V. Fung, J.L. Bosch, J. Kleissl  
[jkleissl@ucsd.edu](mailto:jkleissl@ucsd.edu)

**Overall Comment:**

**The manuscript “Cloud Speed Sensor” by Fung et al., provides interesting and simple method to estimate the cloud motion, however, the weakest party is insufficient data validation analysis. I suggest add more data for different cloud speed because in this version of manuscript the cloud speed is in the narrow range of variation (3-6 m/s).**

**Fig A:** Side view of optical assembly containing the TEPT4400. In the ideal case depicted here the vertical spacing between the diffuser and the TEPT4400 sensor could be  $h = 5.51$  mm. To reduce the effect of tilt errors,  $h = 2.78$  mm was chosen instead.

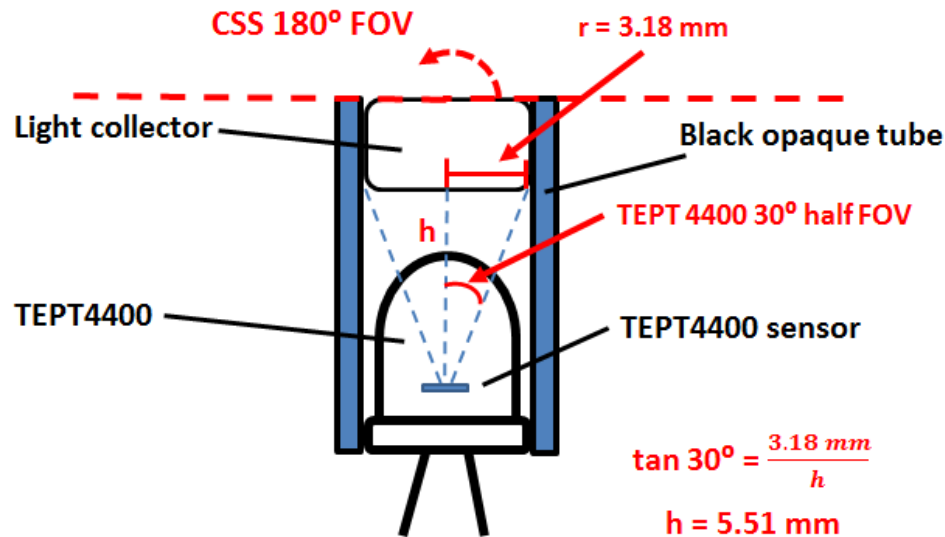
**C2. Page 9021, line 3:** Why the FOV of the sensor is only 30deg? What in case when the sun zenith angle is larger than 15 deg? At San Diego latitude the minimum solar zenith angle is about 10 deg which means that this instrument can be used only during summer and close to noon time. Maybe it is not FOV but half field of view? Anyway the real FOV of sensor should be provided. What is a tilt error for each sensor? Is it in order of 1 deg or larger? Could you add same discussion of that issue on the uncertainty of wind speed and direction? The same for the cosine error of detector

**Response:** While it is true that the FOV for a bare TEPT4400 sensor is  $30^\circ$  on either side of its normal axis, the FOV of the CSS is the entire sky hemisphere. The translucent acrylic collector above each TEPT4400 sensor causes scattering of the incident direct beam such that solar positions that are nominally outside the FOV of the bare TEPT4400 sensor result in irradiance input to the TEPT4400 through scattering in the optical assembly. Therefore, the optical assembly gives the CSS a cosine response over the full  $-90^\circ$  to  $90^\circ$  tilt exposure to the sky and is thus responsive to the full sky hemisphere.

The spacing between the diffuser light emitting surface and the TEPT4400 sensor reduces the effect of TEPT4400 tilt errors. As shown in Fig A, full TEPT4400 sensor exposure to the overhead light field would be accomplished with a vertical separation of  $h = 5.51$  mm. In

the CSS design,  $h$  was decreased to 2.78 mm such that a tilt error of up to  $48.8^\circ$  would still allow the TEPT4400 FOV to be contained within the diffuser area.

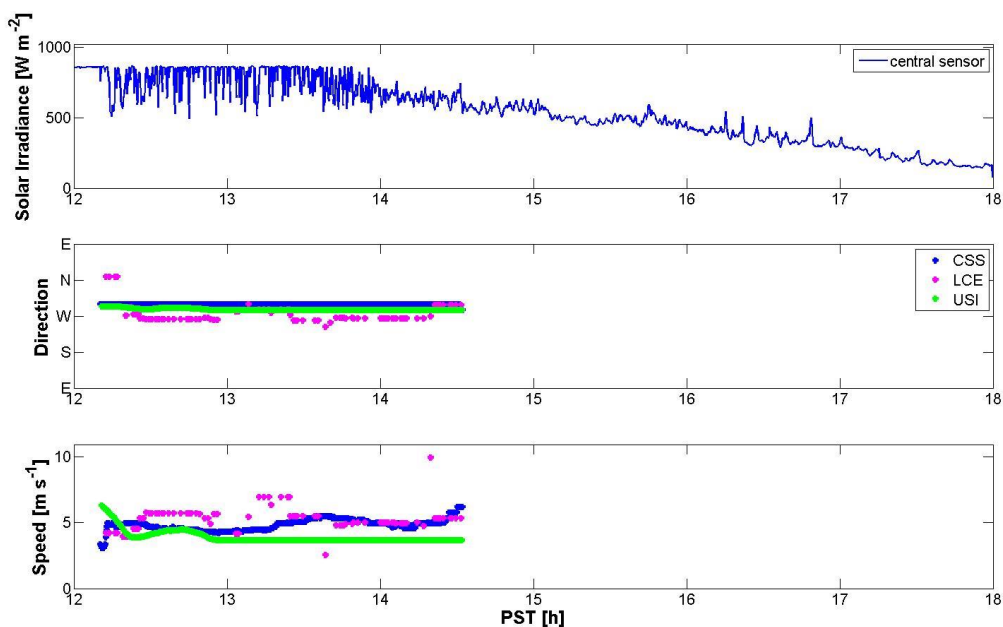
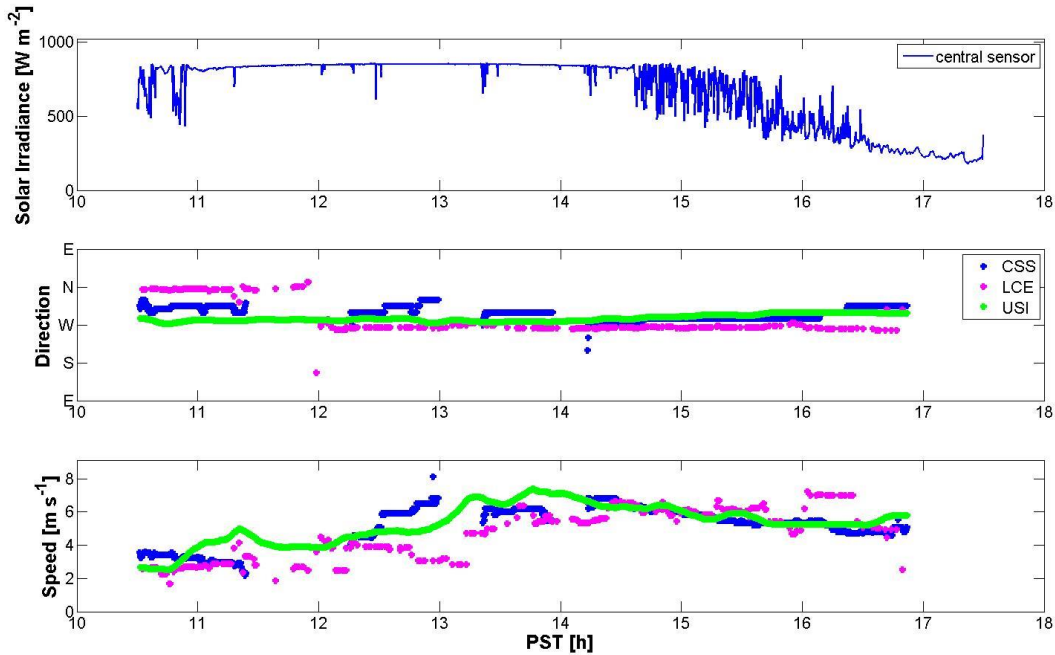
**C4. Page 9058, Fig5:** I propose to remove all data from top panel except for the central sensor because it is impossible to read some difference between sensors. In case of cloud direction and speed the lines should be replaced by the dots or different points. In current version the long blue (green) strait line is misleading. The same for fig. 6.

**Response:** Figures 5 and 6 were edited as suggested by the reviewer.

In addressing we realized that the original top panel was showing the raw Max32 counts reading rather than the calibrated solar irradiance ( $\text{W m}^{-2}$ ). This error has been corrected and Figs. 5 and 6 shown in the response to the **C4** include this correction.

**Fig B:** CSS data prior and after calibrating against a collocated Li-200 pyranometer.

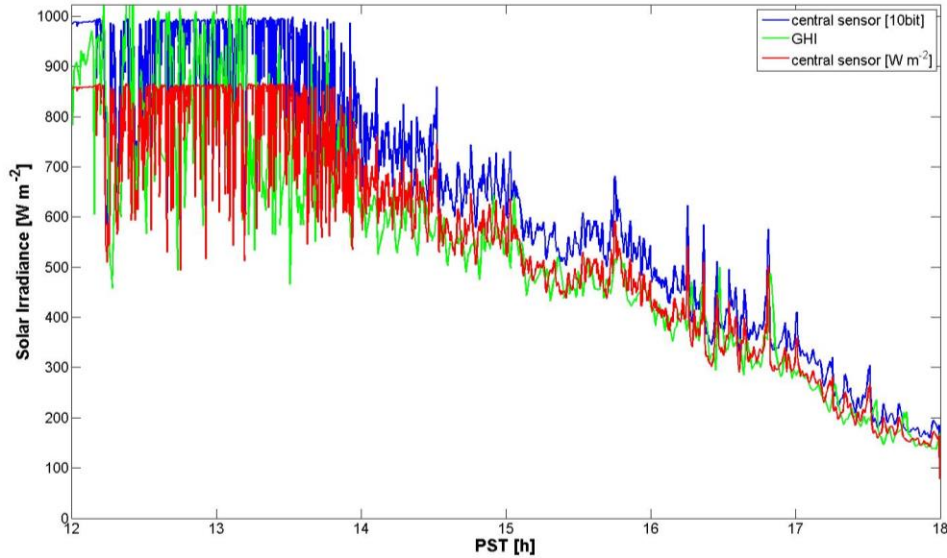
**C5. Page 9058, capture to Fig.5:** It suppose noted that calibration of the central sensor of CSS versus pyranometer has some limitation due to different FOV. In case of pyranometer its 180 and CSS only 30 deg. Therefore such calibration overestimates the solar radiation in the CSS. Probably because of that the solar irradiance (top panel) during overcast condition since 14:00 PST is unrealistic high. If case of low level clouds the solar flux cannot by 800-700  $\text{W/m}^2$  for 100% cloud cover!!!.

**Response:** As mentioned in response to **C2**, the CSS is responsive to the full sky hemisphere. Therefore, the CSS and pyranometer have the same FOV ( $\sim 180^\circ$ ) and can detect solar radiation at zenith angles greater than  $15^\circ$  (i.e. also after 1400 PST).

Regarding the solar flux, Fig B includes the GHI reading from the collocated pyranometer showing the same 600 - 700  $\text{W m}^{-2}$  range as the CSS. Sky conditions between 1300 - 1400 PST as captured by our sky imager are shown in Fig C.
